S E R V I C E N O T E

SUPERSEDES: E4419A-07

E4419A EPM Series Power Meter

Hardware upgrade information.**Duplicate Service Notes:** E4418A-06B**To Be Performed By:** Agilent-Qualified Personnel

Figure 4. U13 Location on Measurement Assy

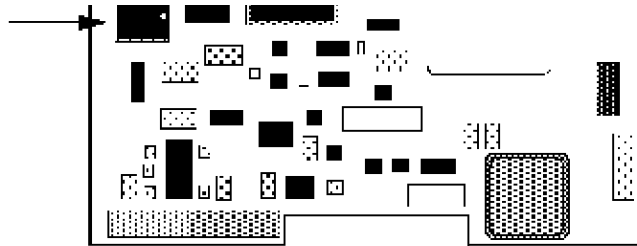
The E4419A requires new hardware pn E4418-80023 and firmware version (A2.04.00 or above) to be fitted in order to make it compatible with the E9300 series sensor. The new E9300 series power sensor requires EPM "A" model dual channel power meters to have firmware version A2.04.00 or greater and have U13 (pn E4418-80003) on the A6 Measurement Assy to be replaced with pn E4418-80023. These changes are required to allow the E9300 series power sensors to operate with the EPM "A" model power meter.

1. Identify U13, See Figure 4 and using the IC extraction tool, remove the EEPROM U13
2. Correctly orientate the EEPROM supplied and insert it into the IC socket.
3. Refit the measurement assembly into the card cage and refit the flex circuits.
